## Model 250RX

### New throttle (Thumb operated throttle)

## 250RX

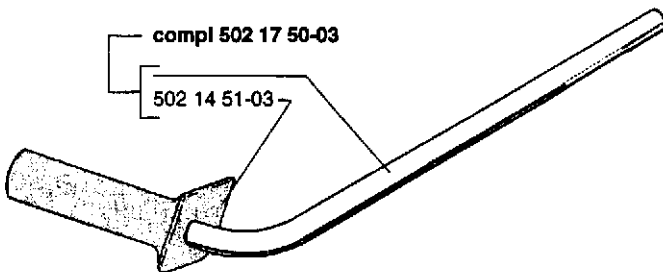
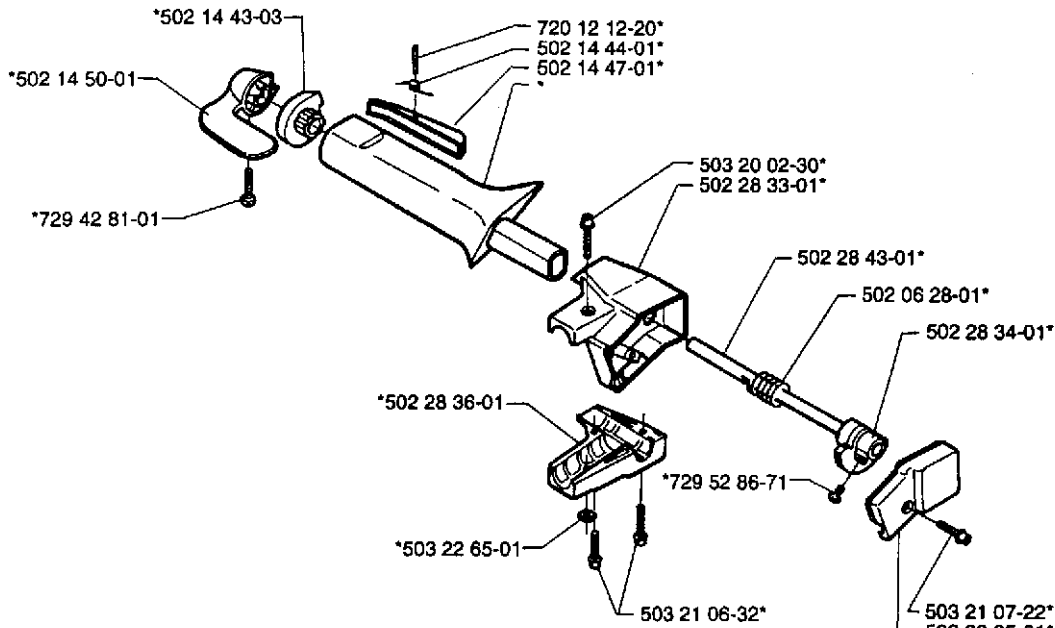
Due to the introduction of swivel handlebars, type 250R, a new throttle has been produced. The handlebars have been supplemented with a through hole to prevent the handlebars from revolving. The tank and handlebar mountings have been changed and are now similar to those on the 250R, see spare part list 1 1994.

\*compl 502 28 37-01

RX \*\*compl 502 27 80-07
